Agenda Item 3
681 Mayflower Road
Replacement Windows and Doors

STAFF REPORT AND RECOMMENDATION

TO:	Chairman Grinnell and members of the Historic Preservation Commission
DATE:	July 26, 2023
FROM:	Jennifer Baehr, Planner
SUBJECT:	681 Mayflower Road – Window and Door Replacement

TO: Chairman Grinnell and Members of the Historic Preservation Commission
DATE: July 26, 2023
FROM: Jennifer Baehr, Planner
SUBJECT: **845 Maplewood Road**
Demolition, Additions, Alterations and Building Scale Variance

EXISTING SOUTH & EAST ELEVATIONS

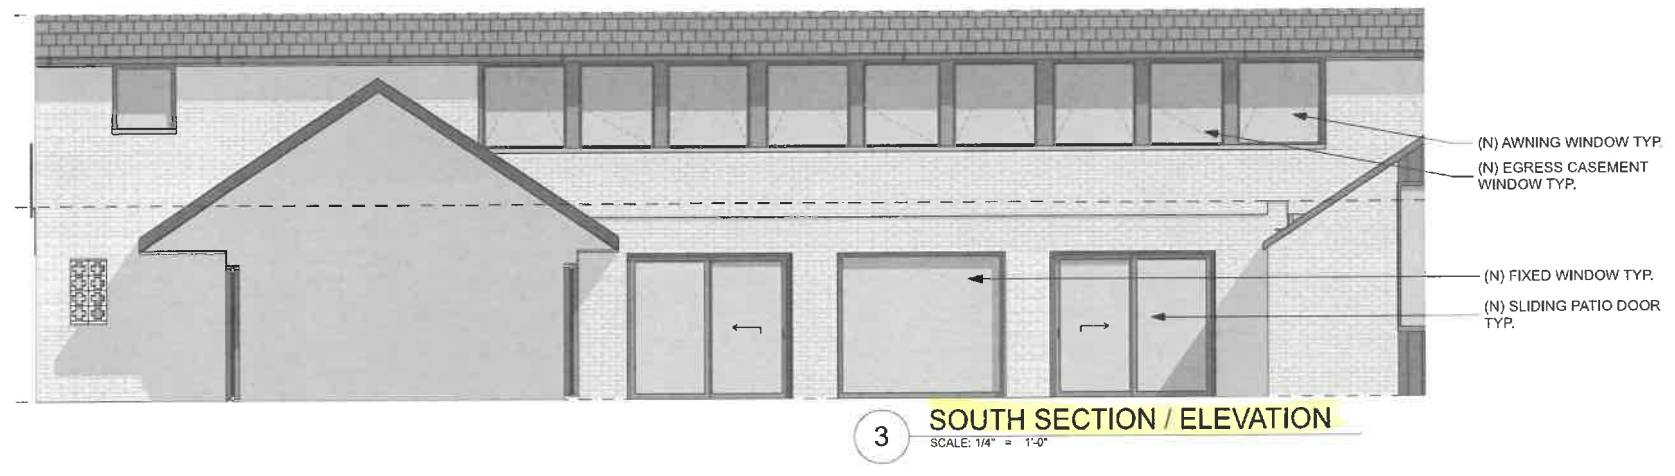
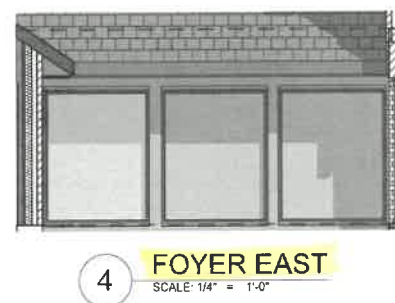
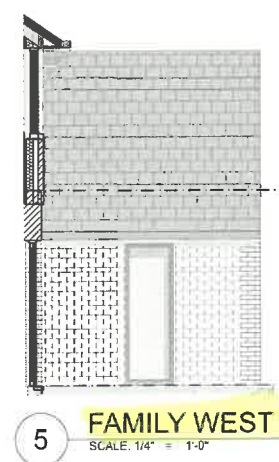
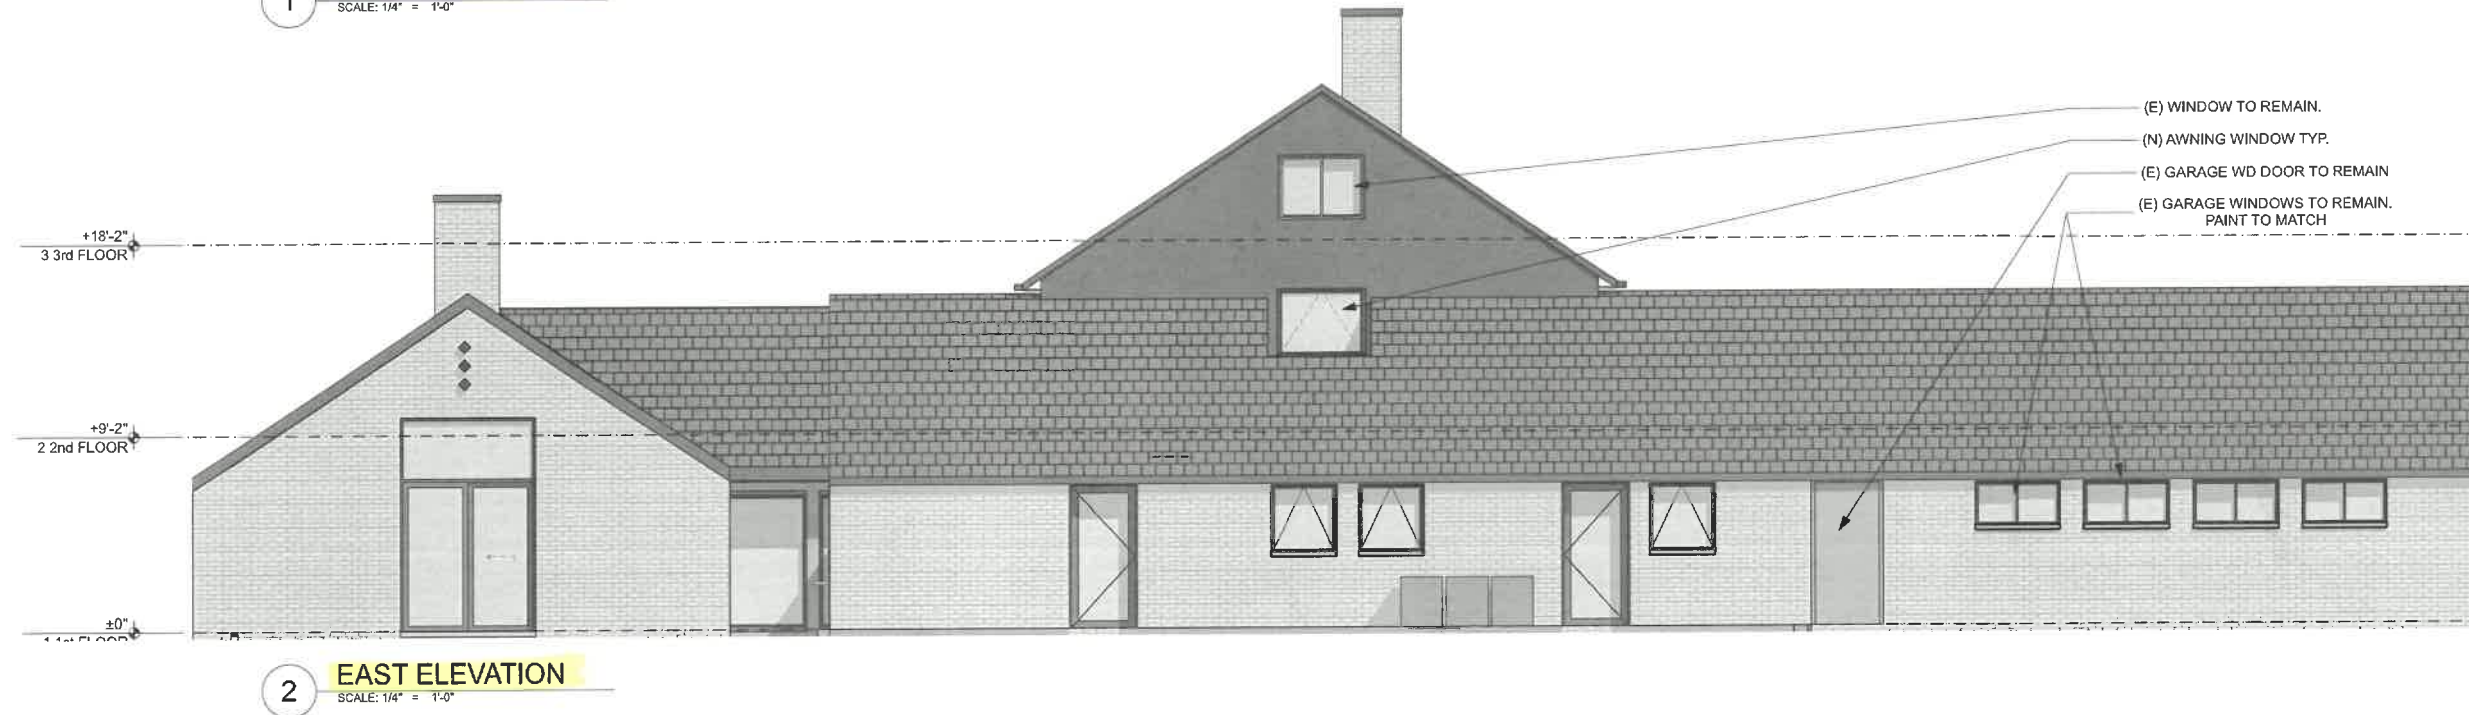
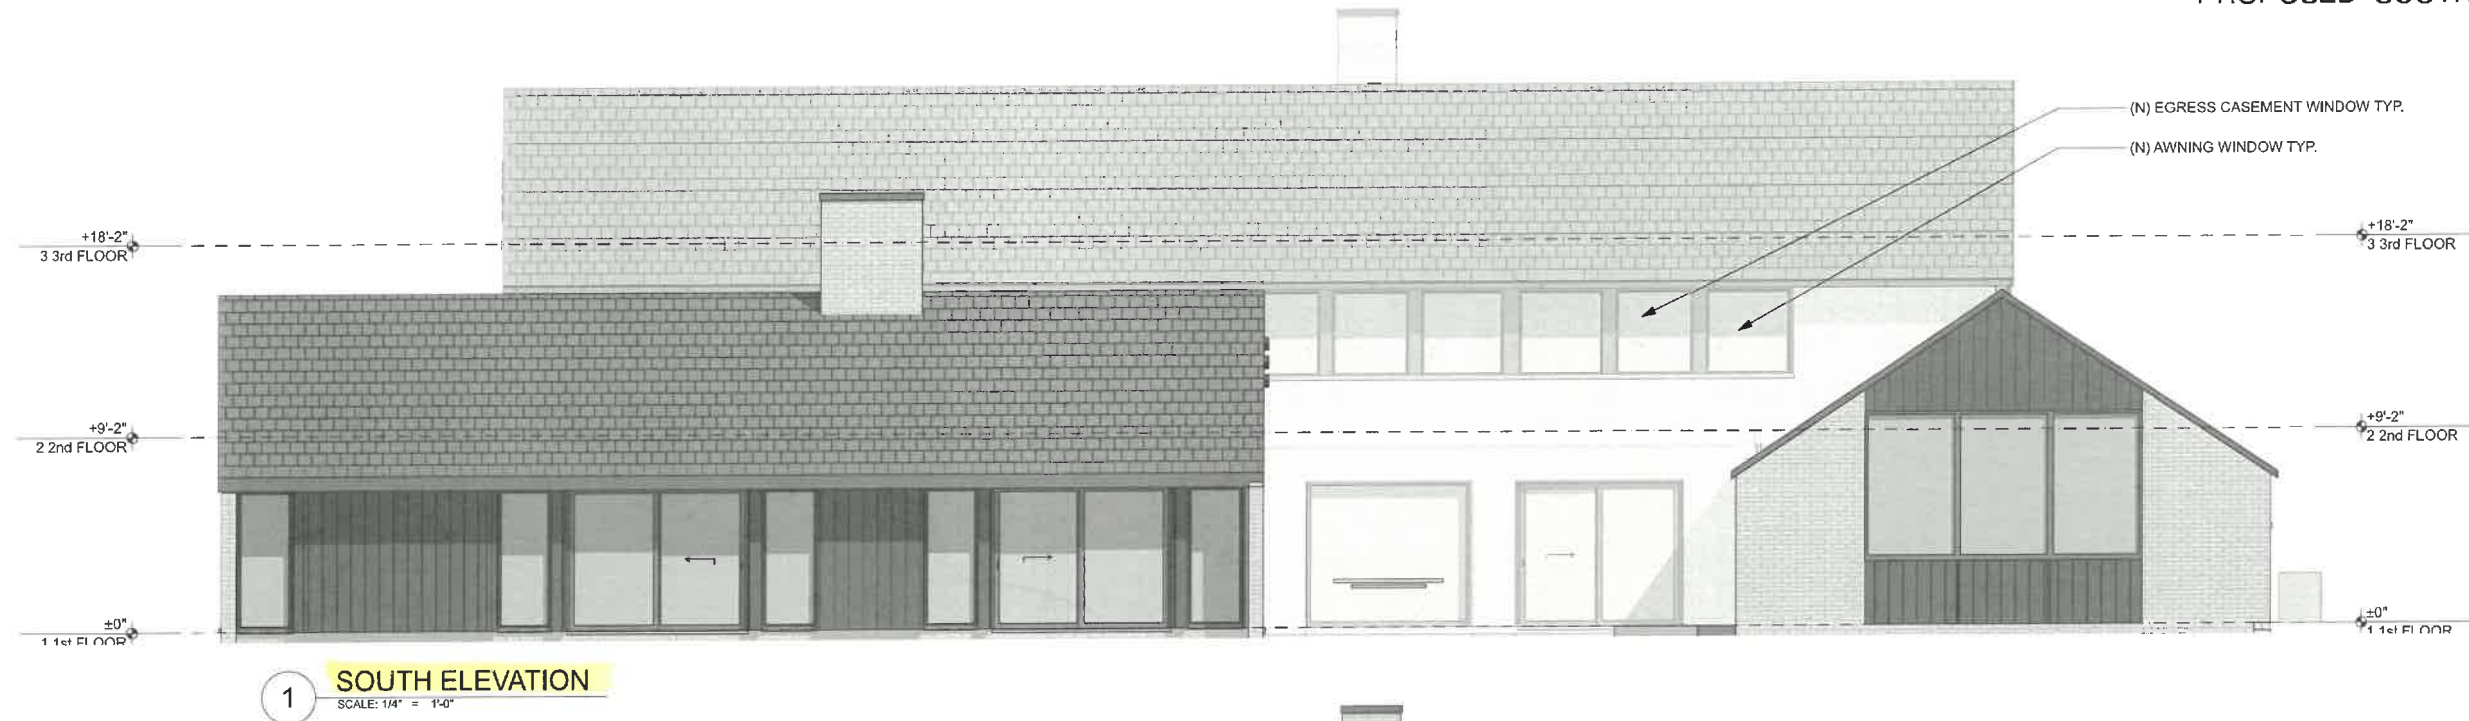
This standard is met. As noted above, although the window and door openings are not being altered, the appearance of the windows will be changing due to the proposed change in the type of windows and the associated change in the divisions. Although the existing slider windows are broken up into vertical proportions, the center division of the existing windows is very thin and is not perceived as a strong vertical element. Most of the proposed replacement windows do not have divisions and therefore appear more square and horizontal in keeping with the contemporary style of the home. As reflected in images provided by the petitioner, other homes in the community designed by Boyd Hill feature square windows without any vertical divisions.

This standard is met. The proposed replacement windows and doors will be installed within the existing openings so the placement of openings and the rhythm of solids to voids will not change.

Grant a Certificate of Appropriateness approving the replacement of the existing windows and doors subject to the following conditions.

PROPOSED EXTERIOR ELEVATION: WEST
333 N GREENBAY ROAD

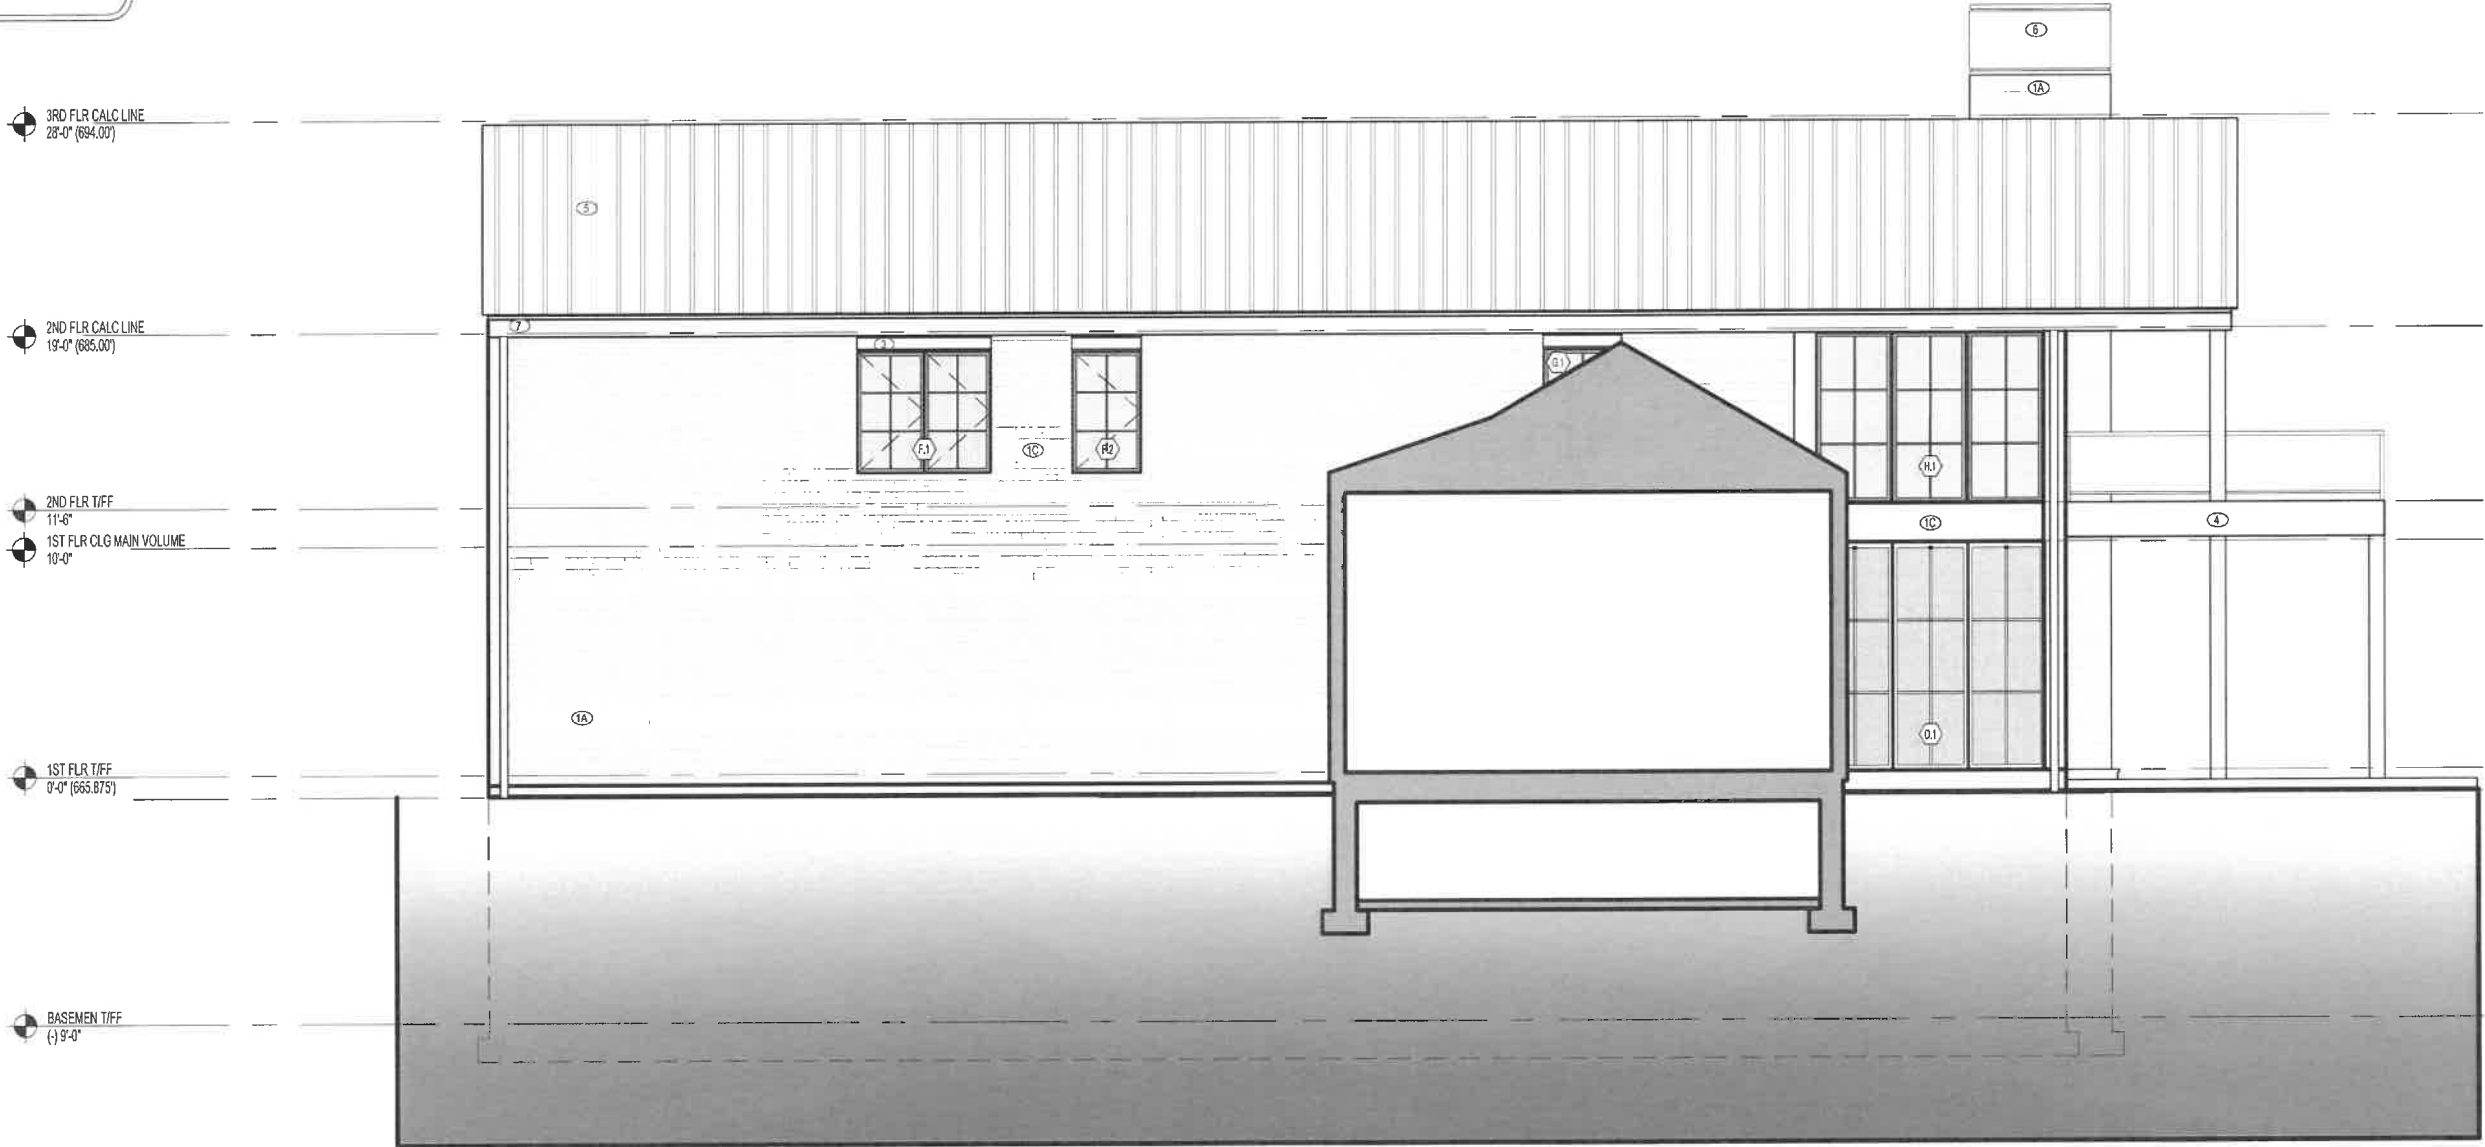
This standard can be met with modifications. The openings around the home are mostly evenly spaced and aligned between the different levels. On the west elevation, a double casement and single casement window are proposed on the second floor that do not appear to follow the rhythm of solids to voids found on the rest of the home. It seems that there may be an opportunity to incorporate an additional window on the north side of the double casement window to provide more balance and a rhythm of openings in this area.

- Staff recommends incorporating an additional window on the second floor of the west elevation to provide a more balanced appearance.
- Staff recommends adding openings to the first floor of the west elevation to break up the large expanse of solid wall.

2. An additional window shall be incorporated on the second floor of the west elevation to provide a more balanced appearance.
3. Openings shall be incorporated on the first floor of the west elevation to break up the large expanse of solid wall.
